**METROPOLITAN GOVERNMENT OF NASHVILLE AND DAVIDSON COUNTY**

**STAFF RECOMMENDATION**  
**2129 Belmont Boulevard**  
**April 17, 2019**

**Application:** New Construction- Addition; Setback Determination  
**District:** Belmont-Hillsboro Neighborhood Conservation Zoning Overlay  
**Council District:** 18  
**Base Zoning:** R8  
**Map and Parcel Number:** 10416009600  
**Applicant:** Matt McCrary, Allard-Ward Architects  
**Project Lead:** Jenny Warren, jenny.warren@nashville.gov

**Description of Project:** Application for the construction of a rear addition, including a left side setback determination.

Figure 3 & 4: Ashwood Avenue elevation windows to be altered

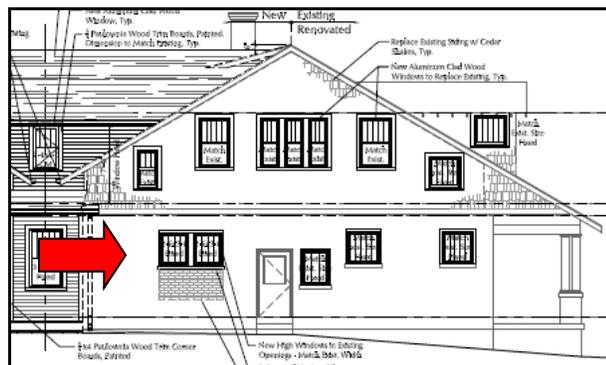
On the side elevation facing Ashwood Avenue, the applicant proposes to alter two original window openings, which is considered partial demolition. The two windows in question are paired, full height 4/1 windows. The applicant is proposing to shorten the height of the windows to create high paired windows that are fixed. As this work is beyond the midpoint of the historic house, staff finds that the window alteration could be appropriate in this situation.

Staff finds that the proposed partial demolition meets section V.2. for appropriate demolition.

Figure 7: Proposed addition in relation to property line and curb.

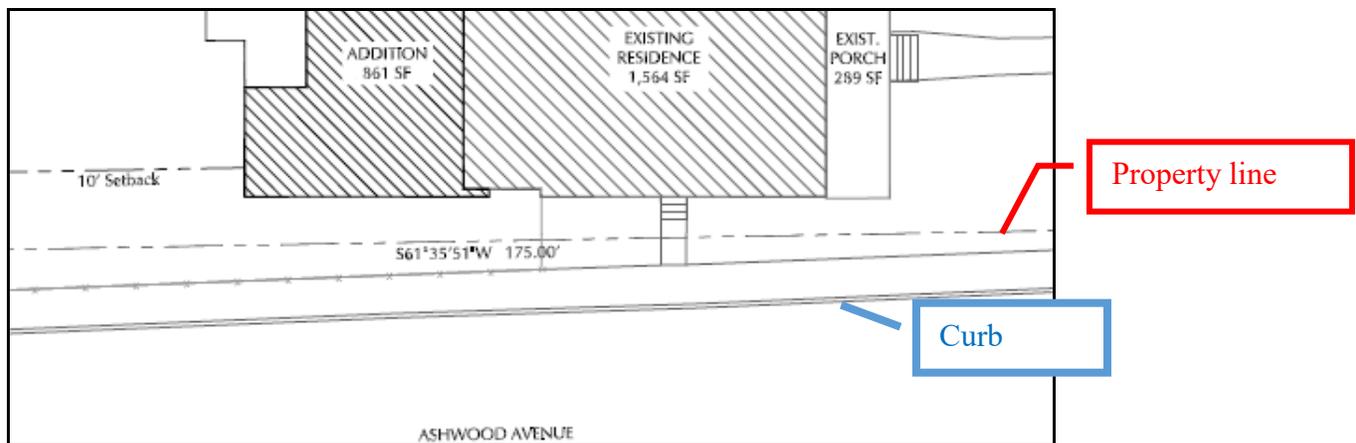
On the left side, along Ashwood Avenue, the proposed addition will be about six feet (6’) from the side property line, while zoning requires a ten foot (10’) side setback for corner lots. Staff is supportive of this setback request for several reasons. The addition lines up flush with the historic house and does not further encroach into the setback. The house sits on the lot at a slight angle as compared to the property line, so at its closest point, the front porch of the house currently sits only about four feet, six inches (4’6”) from the property line. Due to the angle of the house, the addition will sit back further than this, at about six feet (6’) from the property line. Further, the property line sits several feet from the street, meaning that the addition will sit fourteen to sixteen feet (14’-16’) from the curb (Figure 7).

Staff finds that the project meets section II.B.1.c for setbacks.

**AS1.0**

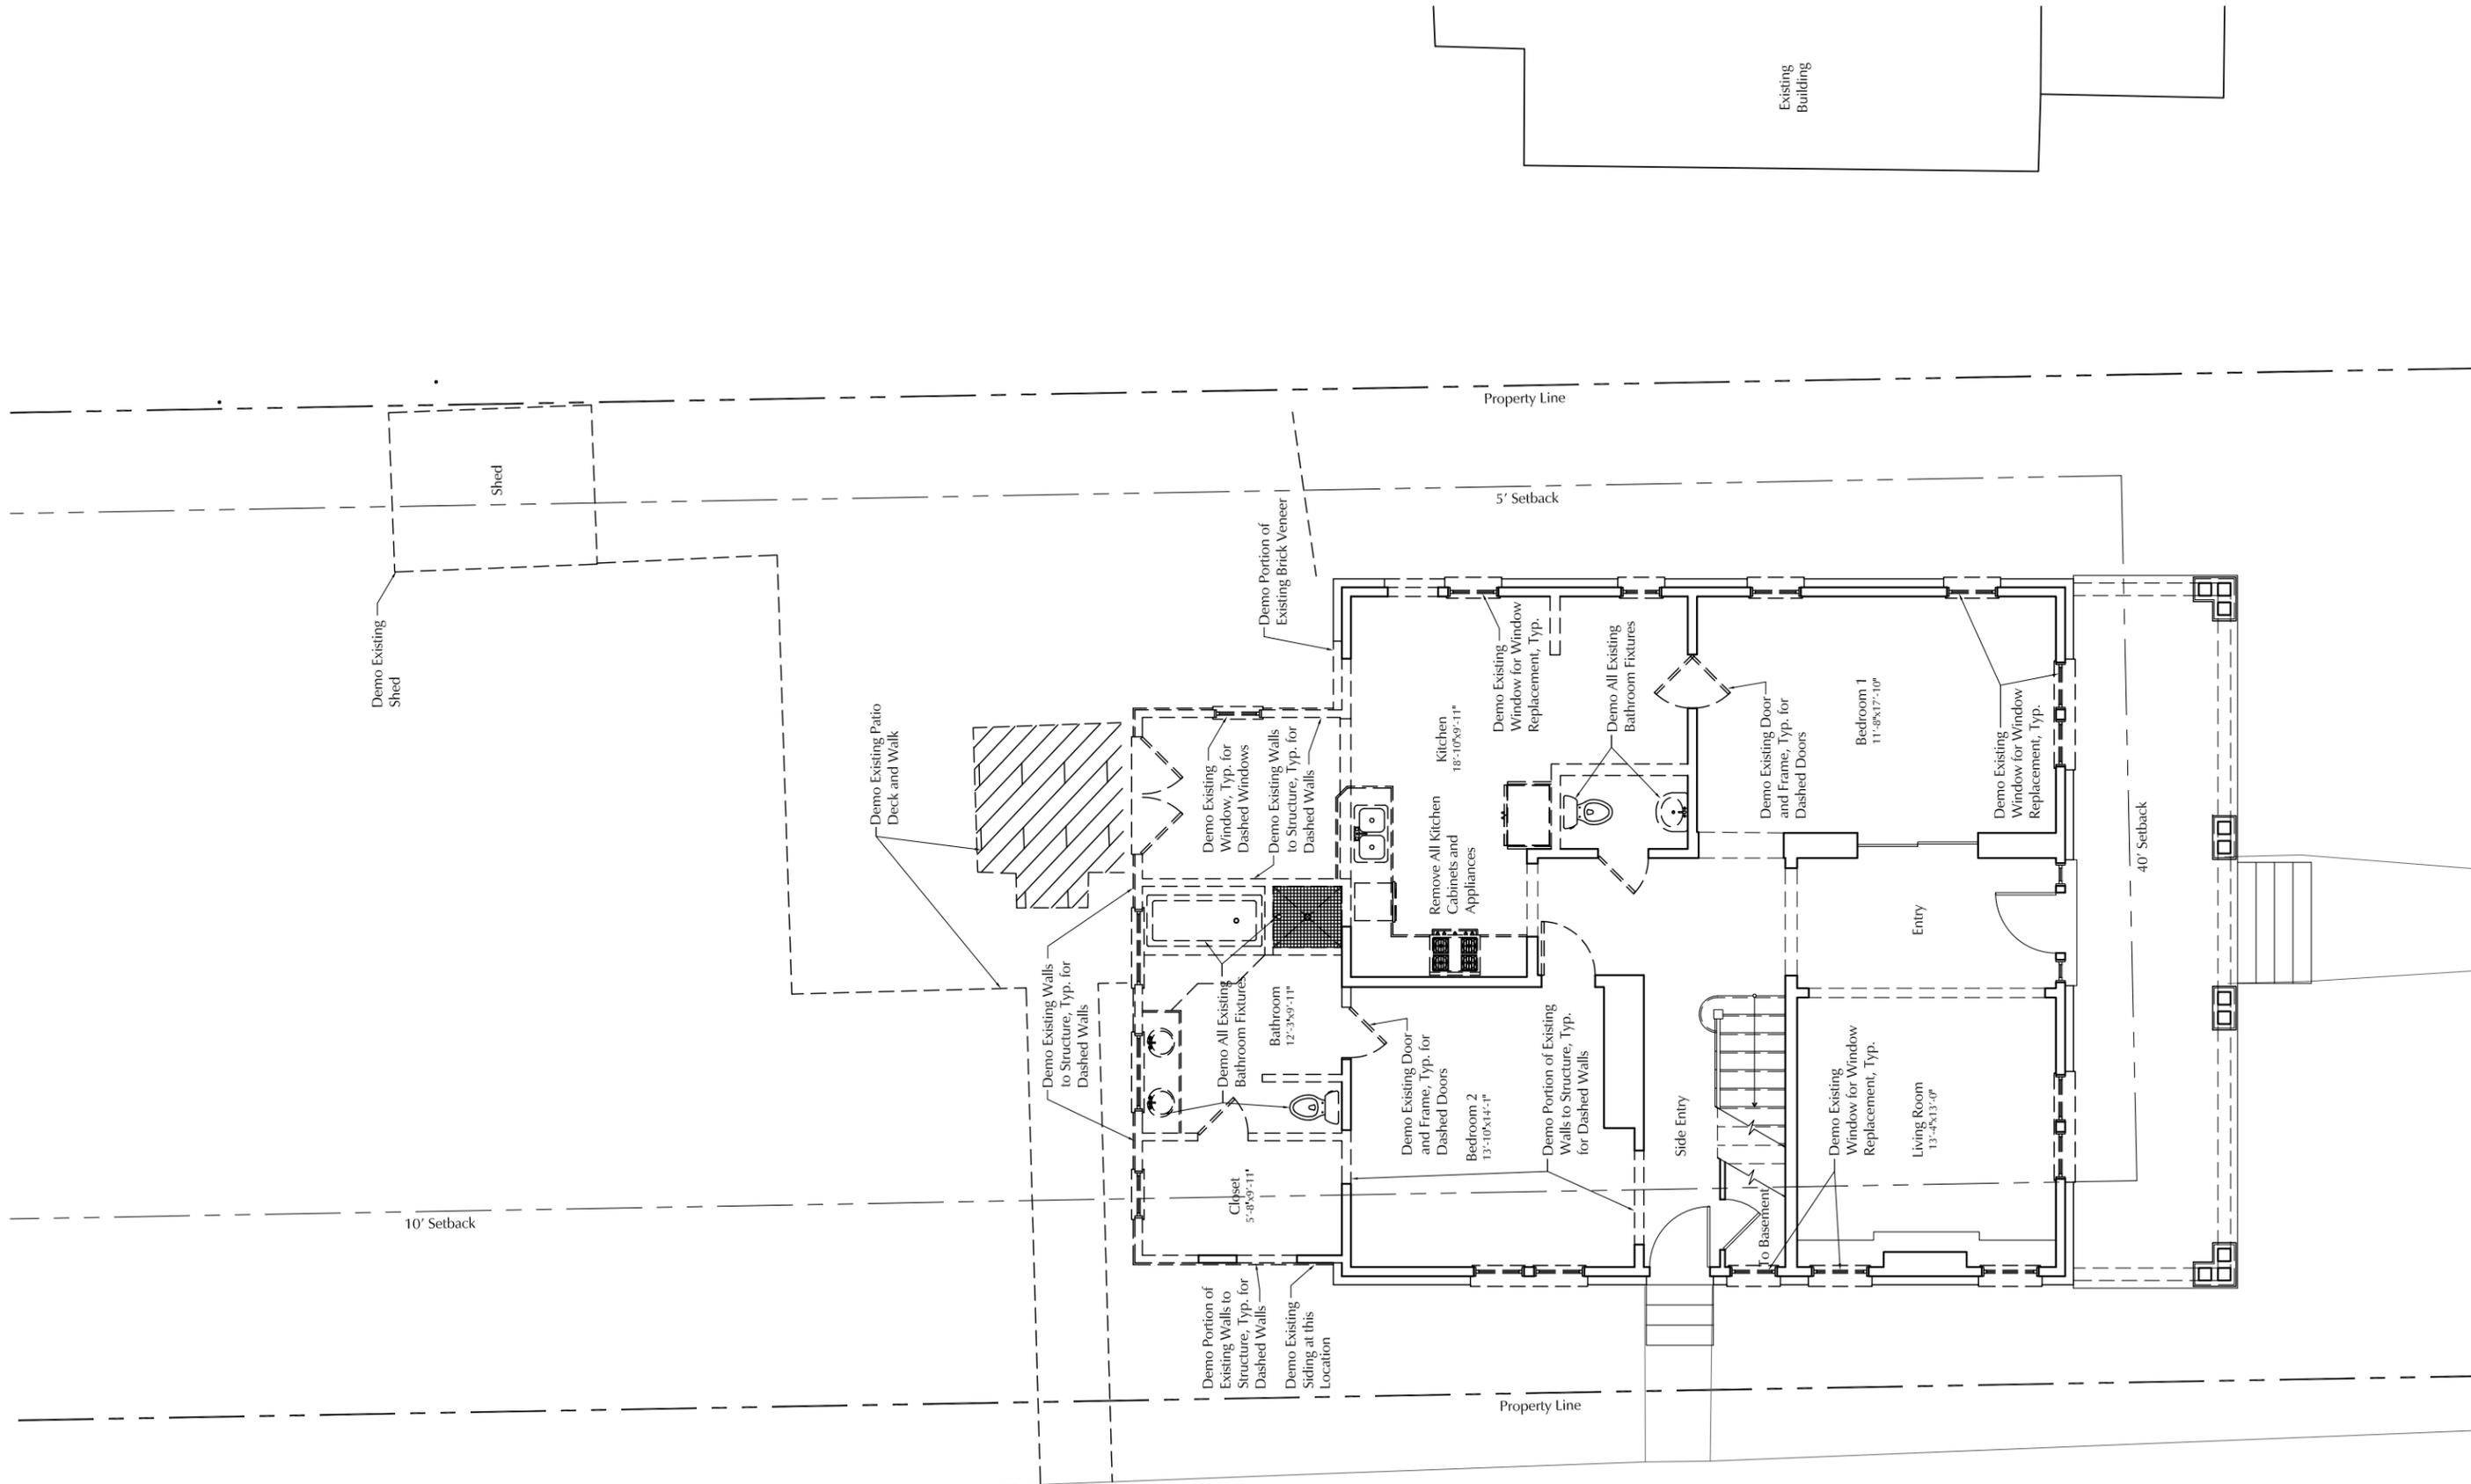
Setback & Rhythm of Spacing: The rear of the addition will be about fifty-two feet (52’) from the rear property line and the left side will be eight feet (8’) from the side property line, at the closest point. These both meet the base zoning requirements.

**A2.1**

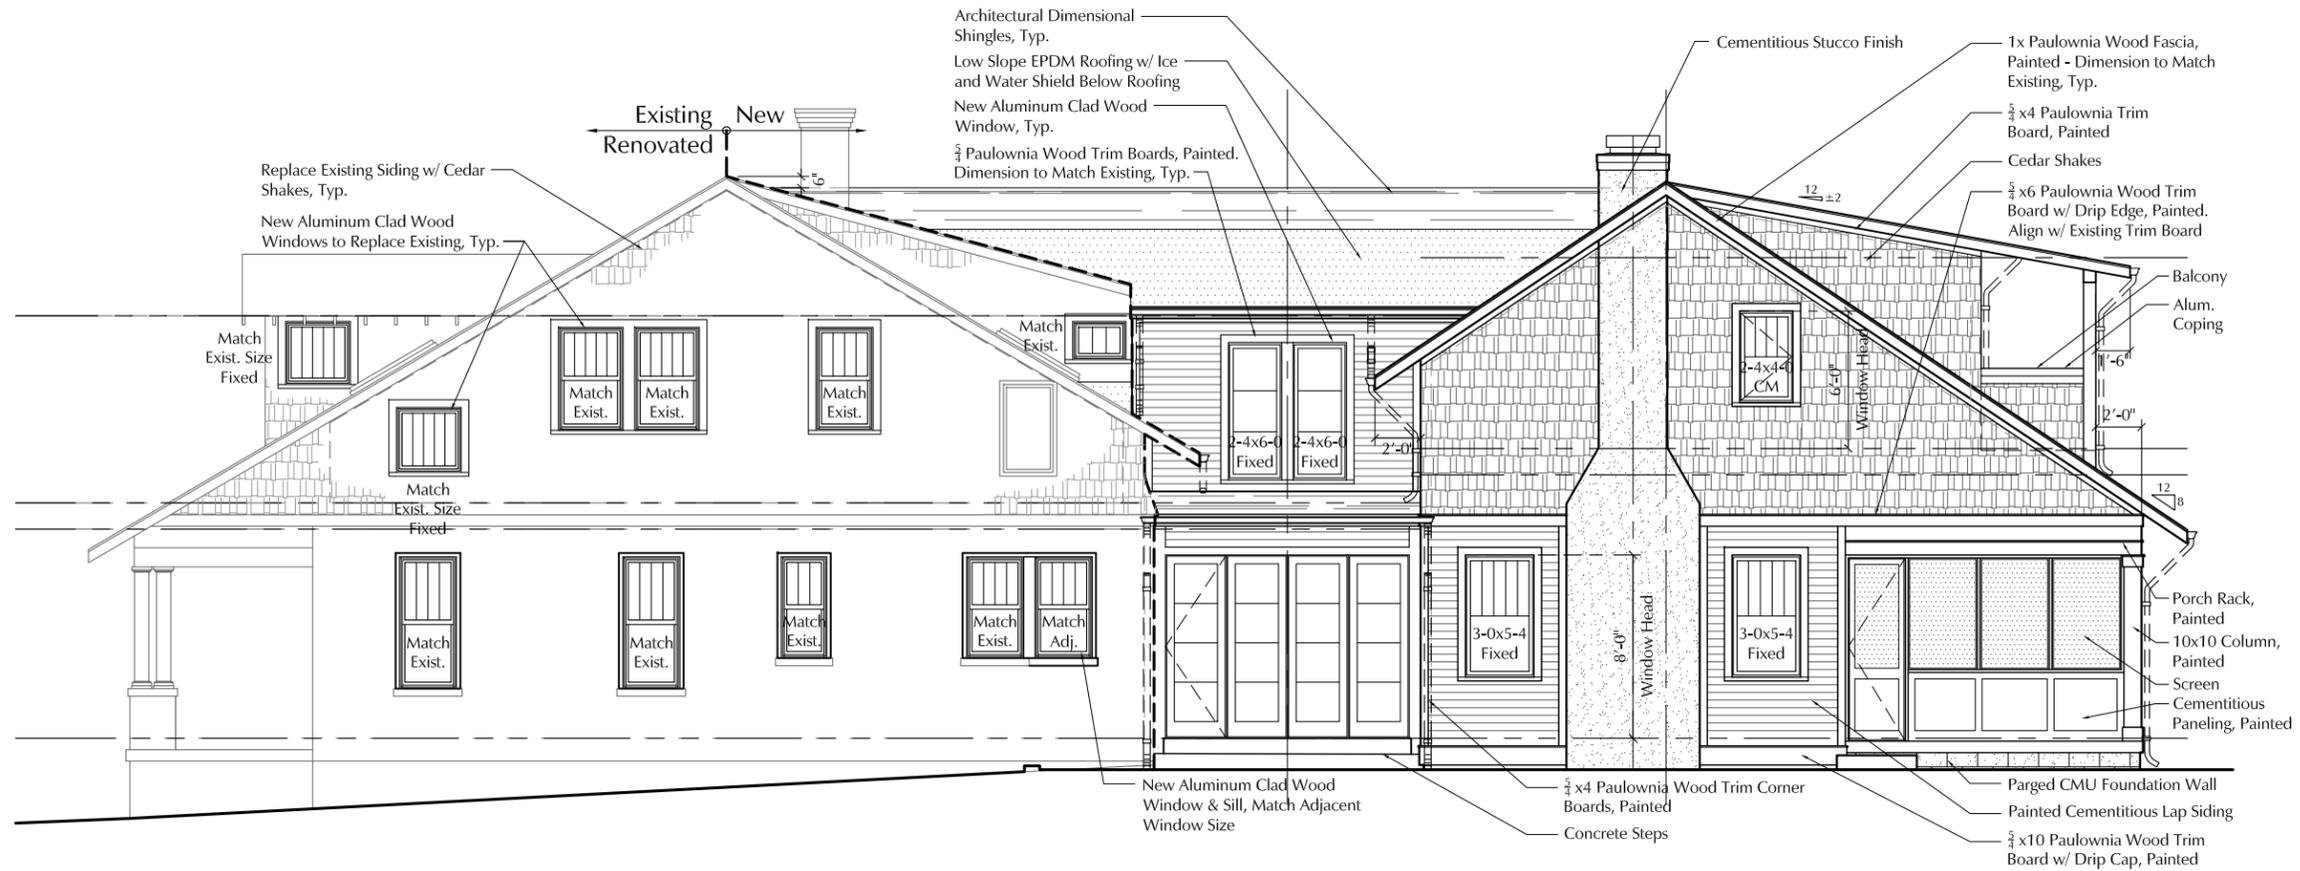
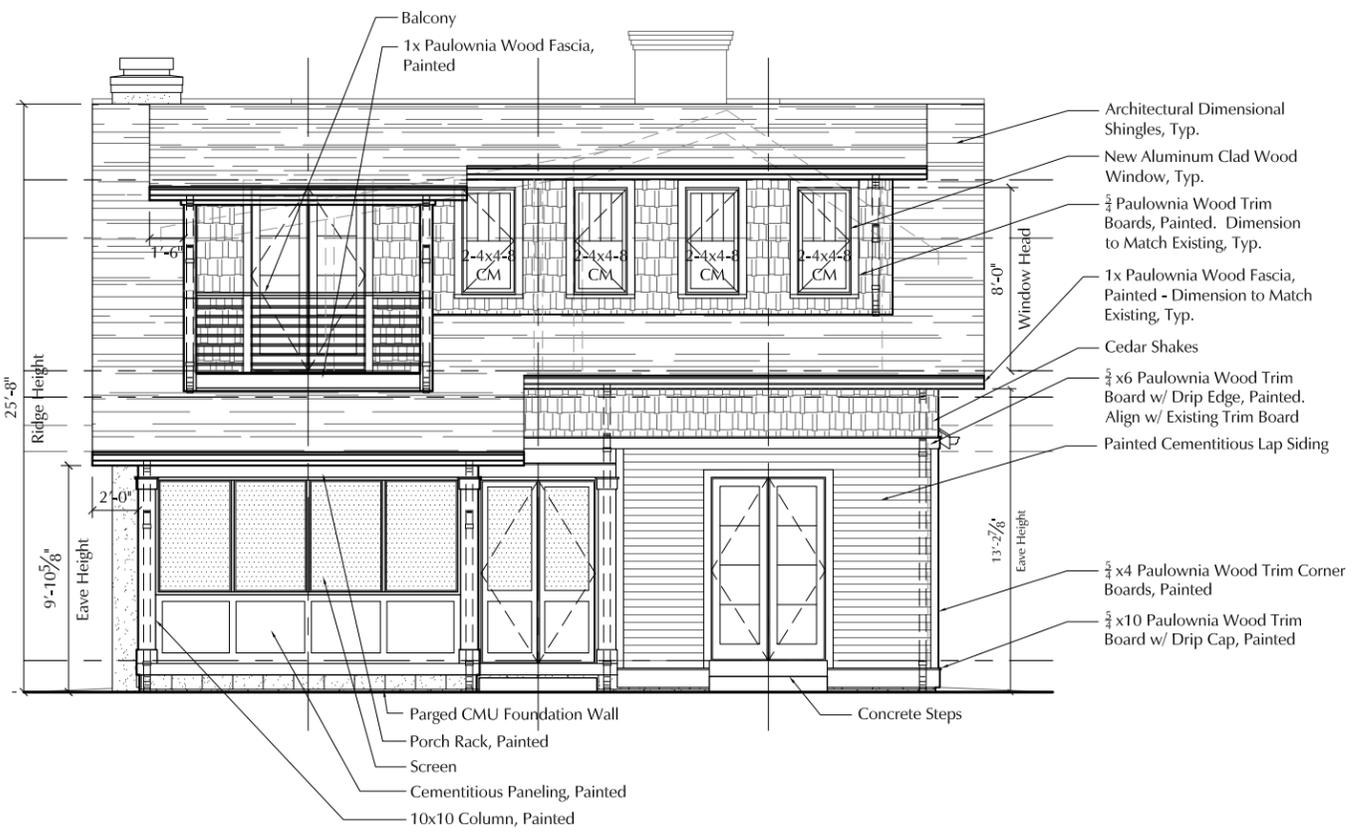
Proportion and Rhythm of Openings: The windows on the proposed addition are generally twice as tall as they are wide, thereby meeting the historic proportions of openings. There is a grouping of three squared windows along the back of the Ashwood Avenue elevation (Figure 5). Staff finds that these square windows are appropriate as several square windows are found on the historic house as well. There are no large expanses of wall space without a window or door opening. Staff finds the project's proportion and rhythm of openings to meet Section II.B.1.g.

Appurtenances & Utilities: No changes to the site's appurtenances were indicated on the drawings. The location of the HVAC and other utilities was also not noted. Staff asks that the HVAC be located on the rear façade, or on a side façade beyond the midpoint of the house. The project meets section II.B.1.h.

1. Staff approve the final doors and windows prior to purchase and installation; and,
2. The HVAC shall be located behind the house or on either side, beyond the mid-point of the house; and
3. Staff approve the material of the back porch columns and the balcony railing.
